Application for Works Approval

Works Approval Number W3102/2025/1

Applicant CITIC Pacific Mining Management Pty Ltd

Premises Sino Iron Project Mine Site
Mining tenements M08/123, M08/124, M08/125, M08/264,
M08/265, M08/266, G08/53, G08/54 and L08/126
MARDIE WA 6714
As defined by the premises map attached to the issued works approval

Figure 2: Typical Stage 1A west embankment section (where Zone C# is Zone C2 material)

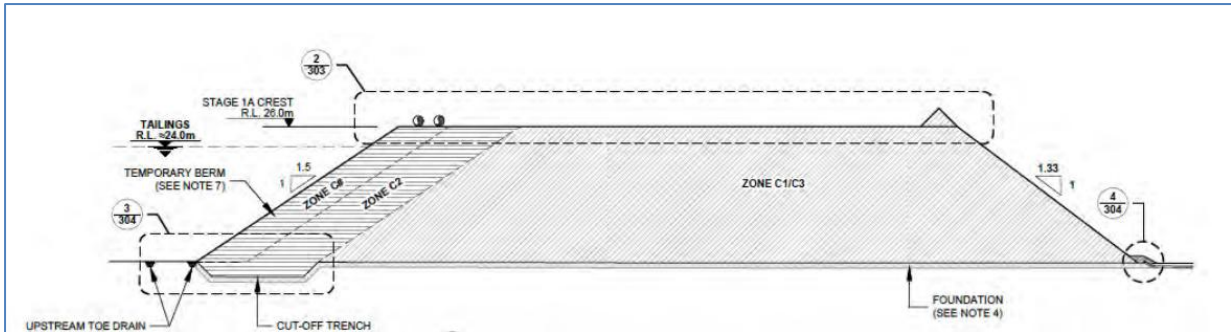
Heading	Summary of public submission comments	Department response
<p>Design Basis and Geotechnical Assumptions</p>	<p><u>Undrained Shear Strength of Foundation Clays</u></p> <p>The design adopts a minimum undrained shear strength of 45 kPa for the fully saturated eluvium and residual soils. This value is derived from laboratory tests on a limited number of samples (e.g., KP-BH01, KP-BH02) and from correlations.</p> <p>Concerns were raised on the range of measured undrained strengths in the laboratory spans 48 kPa to 220 kPa, indicating considerable variability. Moreover, the liquid limit of the eluvium ($\approx 48\%$) and its plasticity index ($\approx 30\%$) place it near the threshold where pore-pressure generation under rapid loading can be significant. A single conservative value may not capture spatial heterogeneity, especially where Gilgai soils are present.</p> <p><u>Recommendation</u></p> <p>Conduct a systematic undrained-strength mapping campaign across the western and north-western embankment footprints, targeting at least six additional boreholes at depths of 0.5–3 m where Gilgai deposits have been identified. Use both triaxial and direct-simple-shear tests to constrain the variability. If the lower-bound strength falls below 45 kPa, the design safety factors for short-term undrained loading (currently 1.5) may be insufficient.</p> <p><u>Shear-Key Effectiveness</u></p> <p>Concern was raised that even if the shear-key's primary purpose is to excise weak material, its presence (or absence) influences the failure-surface geometry. Ignoring it in the finite-element or limit-equilibrium models could underestimate the factor of safety, particularly for shallow failure modes that intersect the toe region.</p>	<p>The matters raised are typically outside the provisions of Part V of the EP Act, so they are not addressed further in this assessment. They are however considered by mining operators to meet legislative obligations for work health and safety under the <i>Mines Safety and Inspection Act 1994</i> and related environmental provisions under the <i>Mining Act 1978</i>.</p> <p>For the comments relating to the undrained shear strength of foundation clays; and shear-key effectiveness the department provides the following:</p> <ul style="list-style-type: none"> • A Geotechnical specialist from the Department of Local Government, Industry Regulation and Safety (DLGIRS) reviewed the design report for TSF 3. • DLGIRS advised that the project provides information consistent with DMPE guidelines and is aligned with Australian National Committee on Large Dams (ANCOLD) and Global Industry Standard on Tailings Management (GISTM) design standards. <p>Refer also to section 2.2.3 in relation to comments from the DMPE.</p>

Heading	Summary of public submission comments	Department response
	<p><u>Recommendation</u></p> <p>Incorporate the shear-key geometry (width, depth, material properties) into the SLOPE/W models for Sections A and B. Perform a sensitivity analysis where the shear-key is omitted to quantify its contribution to overall stability. If the factor of safety drops below the ANCOLD minimum (1.5 for long-term drained conditions), a redesign or reinforcement of the toe zone is required.</p> <p><u>C2 Low-Permeability Material</u></p> <p>The C2 zone is specified to have a permeability of $1 \times 10^{-7} \text{ m s}^{-1}$, yet laboratory tests on 2024 samples yielded values between $6.2 \times 10^{-6} \text{ m s}^{-1}$ and $9.9 \times 10^{-6} \text{ m s}^{-1}$.</p> <p>The over-optimistic permeability assumptions can lead to under-prediction of seepage losses, phreatic-surface rise, and consequently, reduced effective stress in the embankment core. The seepage modelling results (average-pond condition, functional drains) already show a 22.8 kL day^{-1} loss for Stage 9, which would increase substantially if C2 is more conductive.</p> <p><u>Recommendation</u></p> <p>Adopt the measured upper bound ($\approx 1 \times 10^{-5} \text{ m s}^{-1}$) for a conservative seepage analysis, and re-run the SEEP/W model. If the functional-drain scenario yields seepage exceeding 30 kL day^{-1}, consider</p> <ul style="list-style-type: none"> (i) increasing the thickness of the C2 blanket, ((ii) adding supplemental low-permeability liners (e.g., geomembrane) in critical zones, or (iii) revising the drainage layout to ensure redundancy. 	<p>The department has –</p> <ul style="list-style-type: none"> • Conditioned the Zone C2 material for the upstream slope embankment to ensure a coefficient of permeability of $1 \times 10^{-7} \text{ m/s}$ or less is achieved. <p>The applicant will be required to demonstrate that this permeability has been achieved for the Zone C2 material within the Critical Containment Infrastructure Report under condition 5, prior to the commissioning of TSF 3.</p> <ul style="list-style-type: none"> • Conditioned the requirement for a cumulative seepage assessment, which integrates TSF 3 seepage fluxes into the site-wide groundwater model, alongside TSF 2 seepage, pit dewatering and local hydrogeological processes, to assess the combined changes in groundwater levels and salinity at receptor locations. <p>Refer also to section 3.3.</p> <p>The department considers the regulatory controls listed above sufficient to address the public submission comments.</p>

Figure 4: TSF 3 underdrainage system

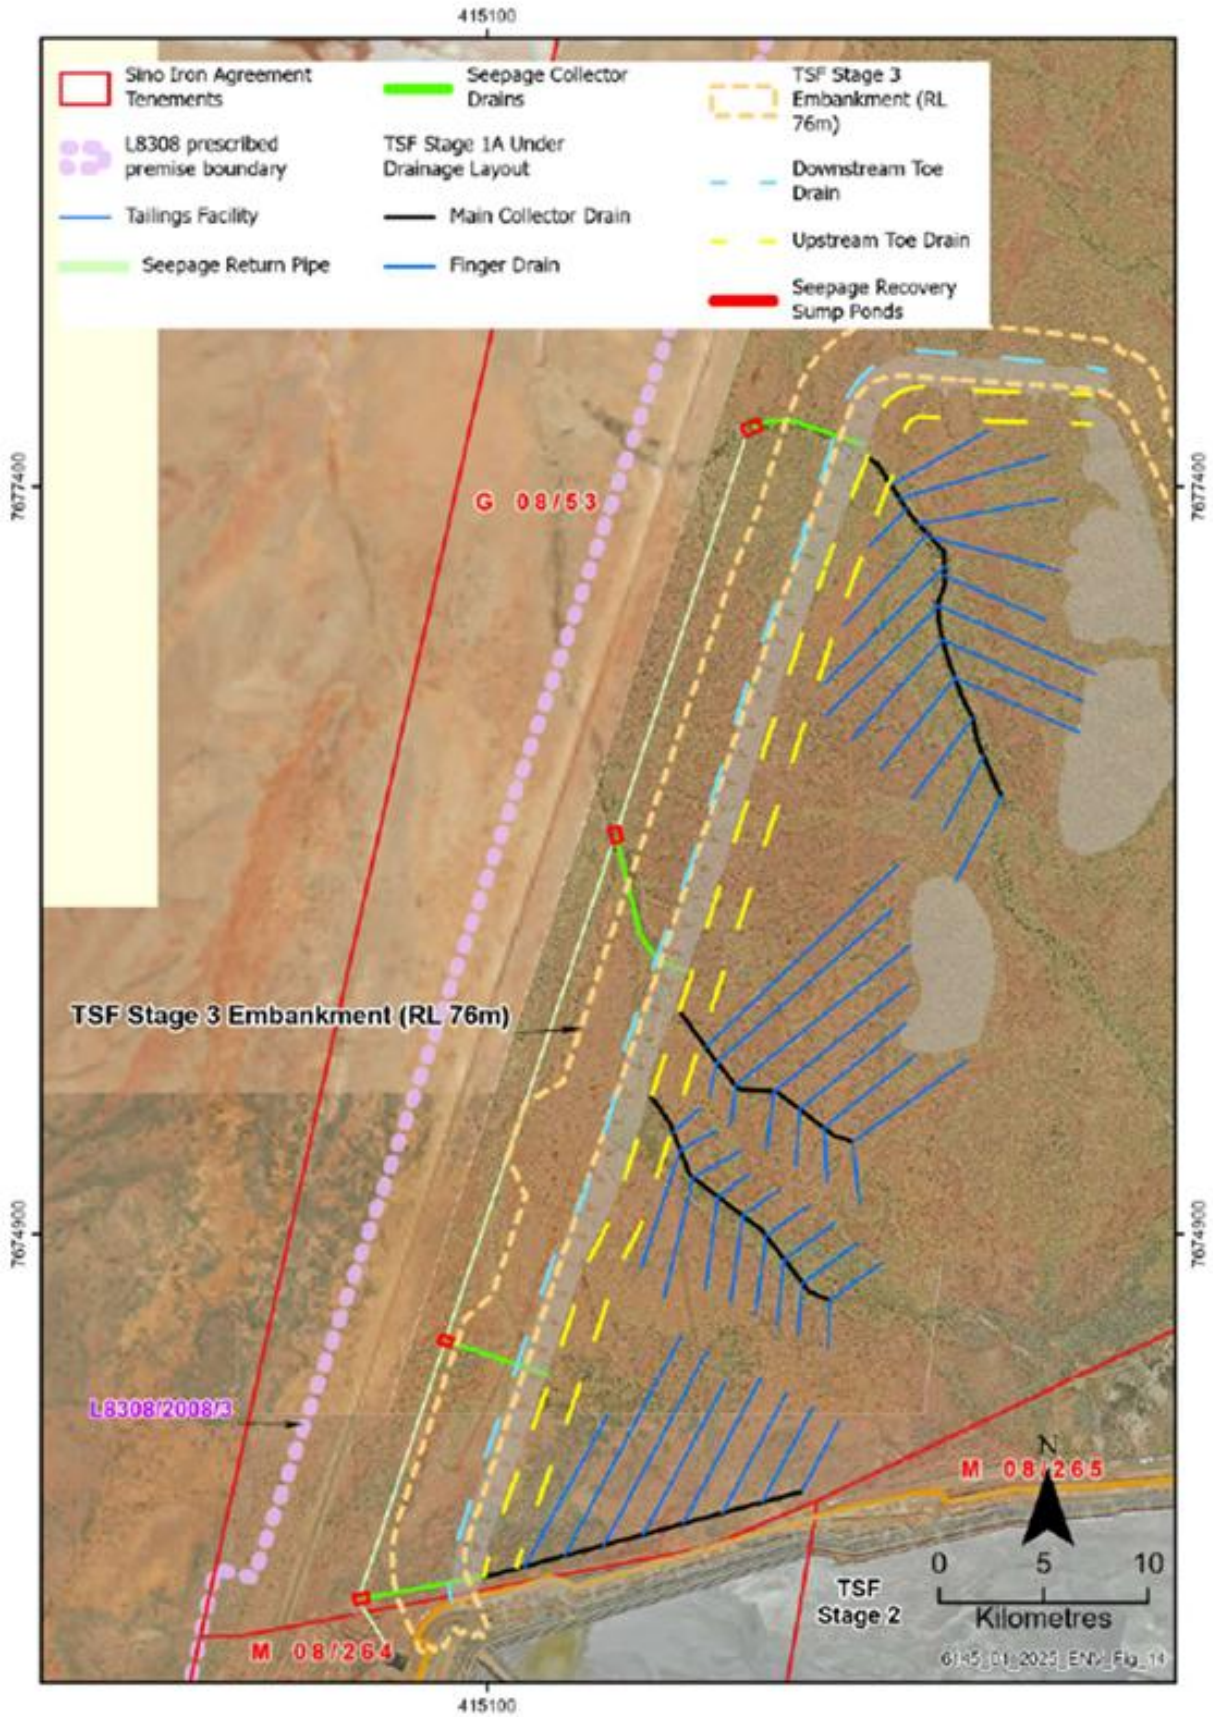
Heading	Summary of public submission comments	Department response
	<p>mandatory shutdown of tailings deposition and activation of emergency drainage.</p> <p>3. Conduct quarterly independent audits of data integrity and sensor calibration.</p>	<p>accessible collector pipes and water chemistry analysis to identify the cause for reduction in seepage.</p> <ul style="list-style-type: none"> Level 3 (Intervention): Piezometric levels approach "Critical" limits. Action: Investigate remedial options based on investigation results. <p>The department has determined not to condition these management actions under the works approval but expects the management commitments to be adopted as part of standard site operating procedures.</p>
	<p><u>Maintenance of Drainage Infrastructure</u></p> <p>The operating manual specifies inspection frequencies (monthly, after heavy rain). However, the functional reliability of the under-drainage system depends on cleanliness of the collector drains and availability of spare pumps.</p> <p>Blockage of the basin drains was identified as a high-impact failure mode (doubling seepage loss). The manual lacks a preventive-maintenance schedule (e.g., scheduled flushing, debris removal).</p> <p><u>Recommendation</u></p> <p>Implement a preventive-maintenance programme that includes:</p> <ol style="list-style-type: none"> Bi-annual flushing of all collector drains with high-pressure water jets. Installation of filter screens (mesh ≤ 10 mm) at inlet points to capture coarse debris. Keeping a stock of spare pump units on site, with quarterly functional testing. 	<p>The department has determined not to condition the preventative maintenance programme recommended.</p> <p>The applicant has advised the performance of the underdrainage system is monitored through a combination of hydraulic and volumetric indicators. A "progressive degradation" would be detected through the following signals:</p> <ul style="list-style-type: none"> Volumetric Flow Rates: Each drainage sector is equipped with flow measurement devices at the sumps. A consistent, downward trend in flow rates compared to predicted seepage models (at a given tailings head) would indicate potential pipe clogging. Piezometric Head (Pore Pressure): Piezometers (VWP) installed at the foundation-tailings interface are the most critical sensors. An upward trend in pore water pressure at the base, while the supernatant pond remains stable, is a direct indicator that the drainage system is failing to dissipate the hydraulic head <p>No underdrainage system maintenance is proposed during operations. To ensure long-term functionality, the following design features are incorporated:</p> <ul style="list-style-type: none"> Filter Design: The basin and toe drains utilise a multi-stage granular filter (specifically graded sand and

Heading	Summary of public submission comments	Department response
		<p>aggregate) designed to be internally stable and self-filtering, preventing the migration of fine tailings into pipes.</p> <p>The department determines the applicant's response adequate to address the public submission comments.</p> <p>The department will not impose additional regulatory controls.</p>

Figure 5: TSF 3 groundwater monitoring and seepage recovery bores

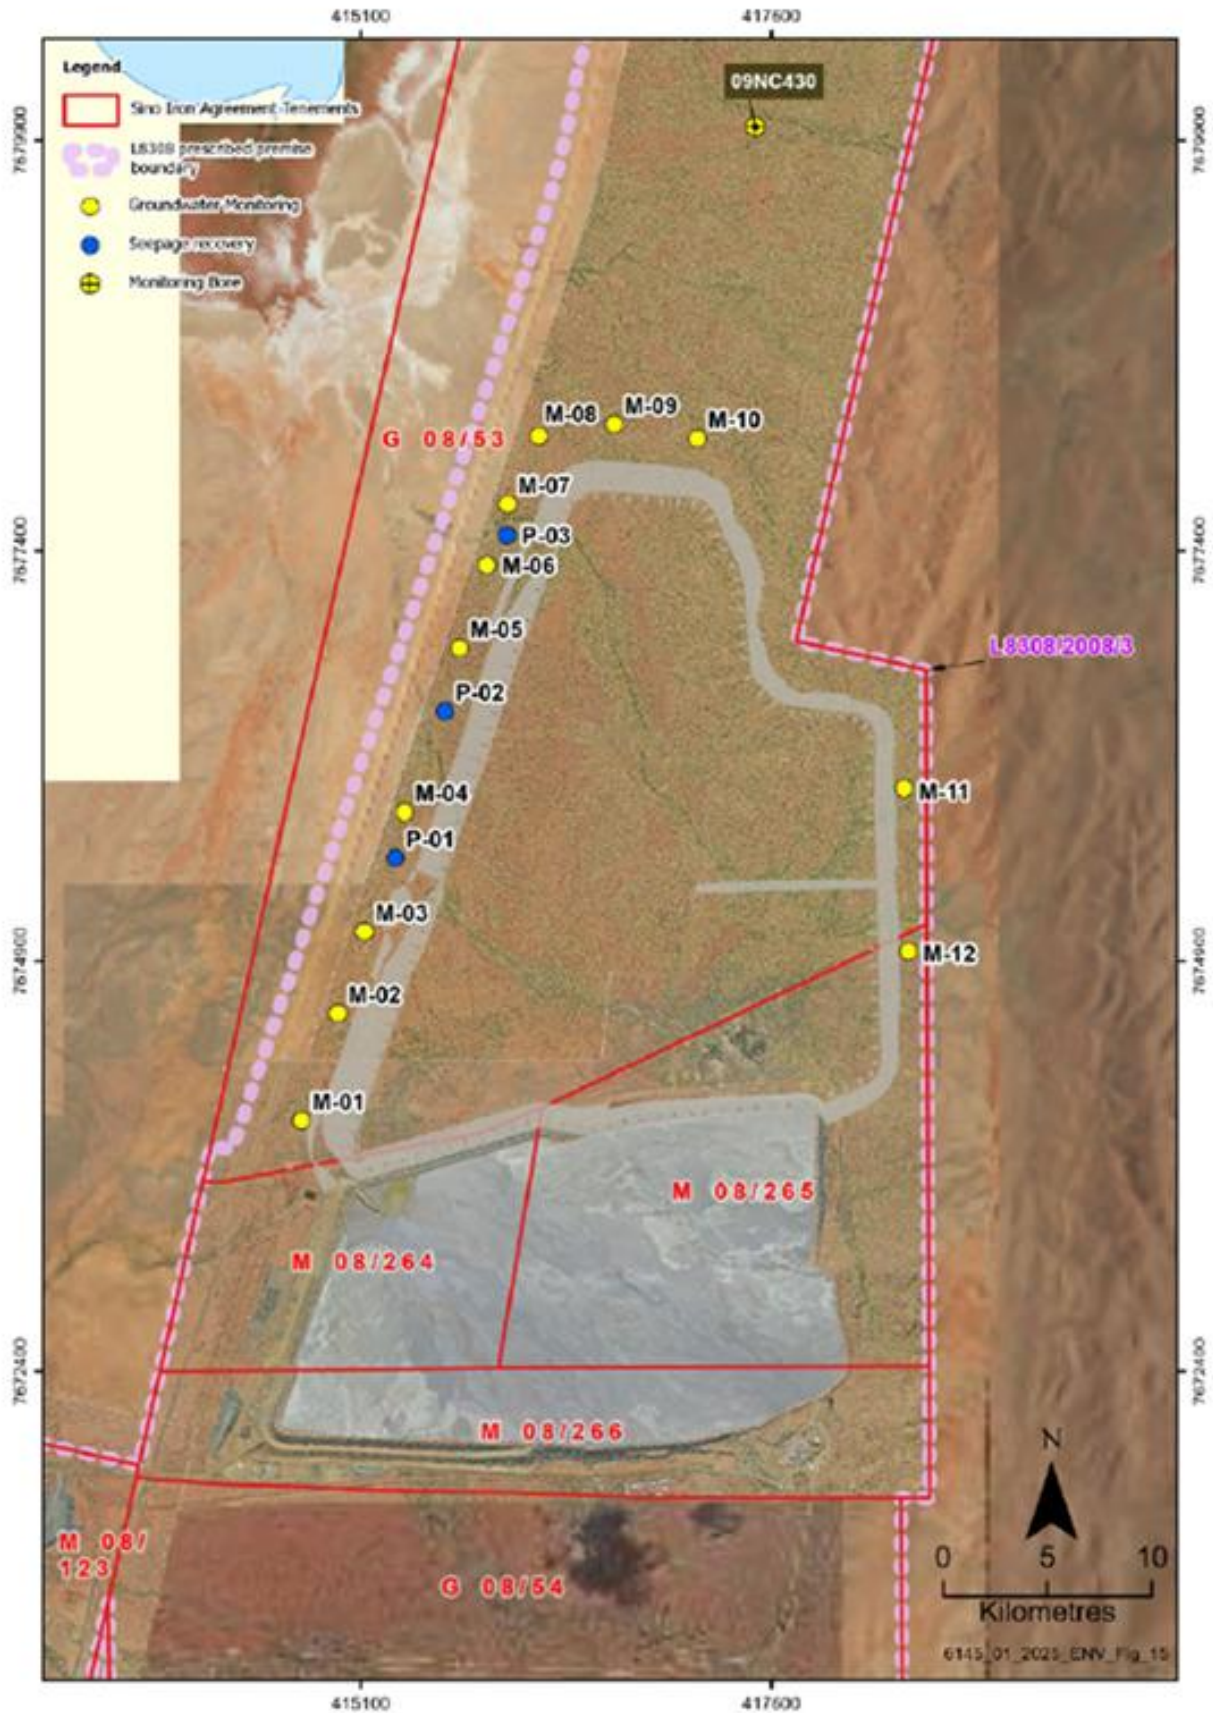
- Installation of at least one background/upgradient bore located outside the expected influence of TSF 2, TSF 3 and dewatering, to provide a stable reference for groundwater levels and chemistry.

- Definition of clear trigger and limit values for groundwater levels and Electrical Conductivity / TDS (and selected ions where relevant to receptor sensitivity) and linking these to action plan that sets out when to investigate, adjust operations, rehabilitate drains or activate/increase recovery pumping.

The department notes that the drilling of the bores commenced in February 2026. Based on this, condition 8 has been applied through the works approval which requires the applicant to provide a report following construction of the groundwater monitoring and seepage recovery bores.
